ADDENDUM NUMBER ONE – DECEMBER 3, 2020

PROJECT: **Metroparks Toledo – Howard Marsh Phase 2, 611 S. Howard Road, Curtice, OH 43412**

Metroparks of the Toledo Area would like to issue Addendum #1 related to the above indicated project.

ENLARGED DISTRIBUTION
PUMP PLAN
HOWARD MARSH CELL 2
WETLAND ENHANCEMENT
TOLEDO, OHIO
LUCAS COUNTY

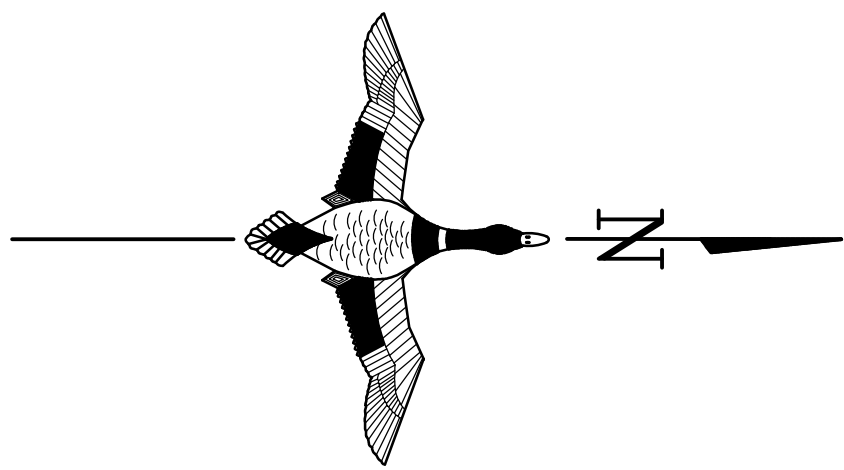
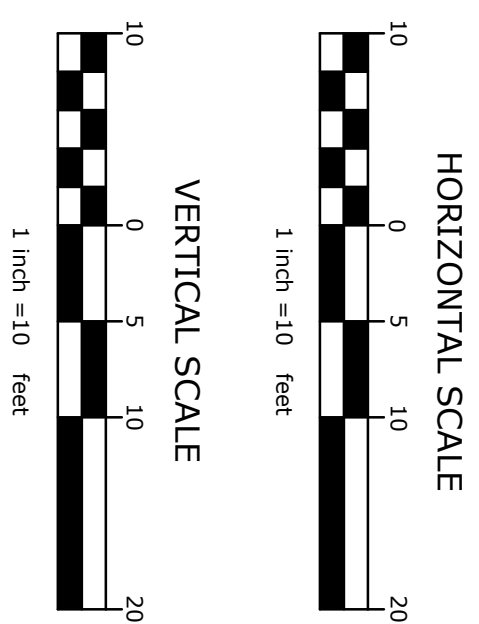
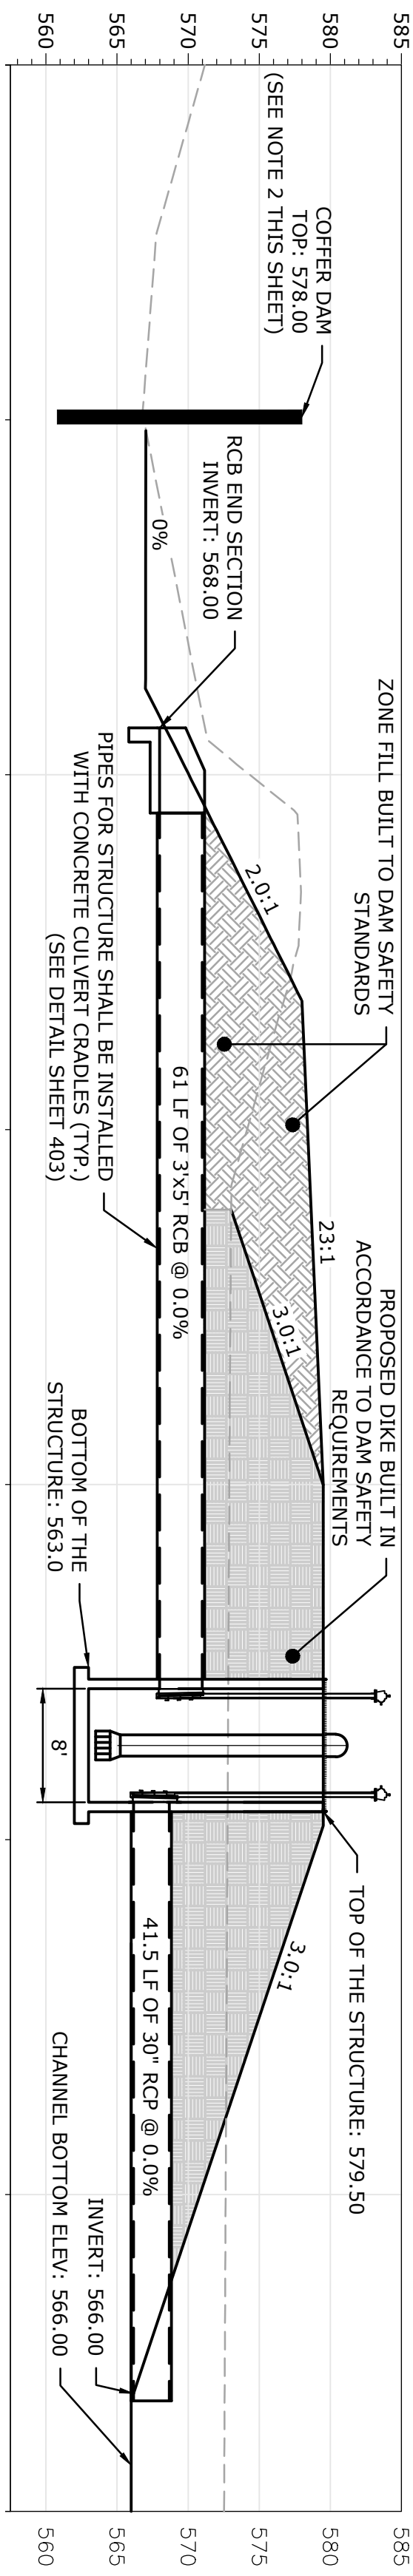
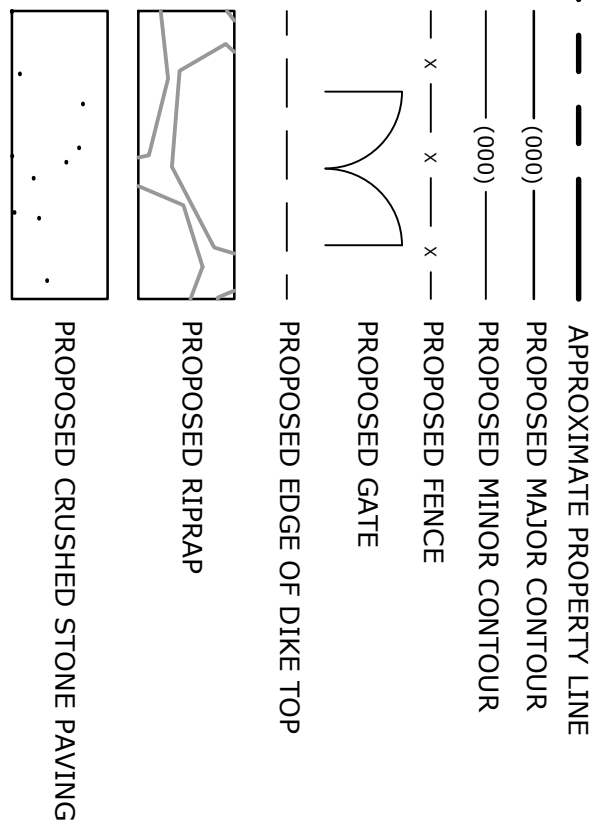
Question: *Culvert lengths on the plan view do not match the culvert lengths provided on the profile view, which lengths will apply?*

Response: Please refer to corrected replacement plan sheet 207 attached herein.

Revisions	Date	By
STRUCTURE PIPE LENGTHS	12/02/2020	PML
